**1. COA-081584-2020**

2206 East Broad Street

# Commission of Architectural Review

**Convert rear porch roof to a second story balcony.**

Figure 4. 2206 East Broad Street, rear elevation.

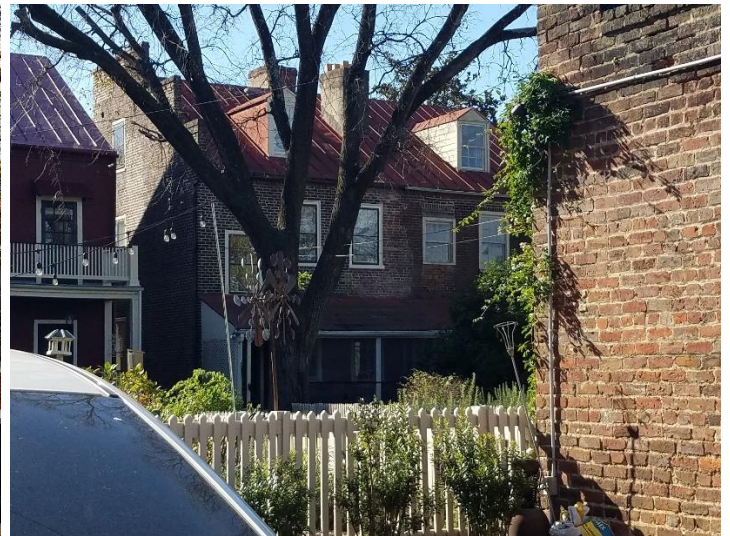
Paint, Frame Structures #6, pg. 63	<i>The handrails of wooden porch railings are often painted a dark color while the pickets are painted white or off-white.</i>	Paint colors were not indicated in the application. <u>Staff recommends the porch be painted to match the existing porch, or new colors be submitted to staff for administrative approval.</u>
Porches, Entrances and Doors #4 pg. 71	<i>Front and side porches are architecturally more ornate than utilitarian back porches.</i>	The applicant is proposing to remove the roof of the rear porch to create a balcony. Staff notes that the porch is currently shared with the attached home at 2204 East Broad Street and <u>recommends details regarding the treatment of the attached porch be submitted for administrative review and approval.</u>
Porches, Entrances and Doors #5 pg. 71	<i>The entire porch should only be replaced if it is too deteriorated to repair or is completely missing; replacements should match the original as much as possible.</i>	The existing first-story porch posts will be removed and replaced with pressure treated posts wrapped in composite trim with decorative capitals and bases. The current porch has simple square wood posts and staff finds the proposed posts are more ornate than the existing design. As ornate designs are not appropriate for rear porches, <u>staff recommends the existing posts be retained or replaced in-kind with new square wood posts.</u>

- The porch be painted to match the existing porch, or new colors be submitted to staff for administrative approval.
- Details regarding the treatment of the attached porch be submitted for administrative review and approval.
- The existing posts be retained or replaced in-kind with new square wood posts.
- A half-round metal gutter be installed, and specifications be submitted for administrative approval.
- The Richmond rail be wood painted a neutral color found on the Commission palette.
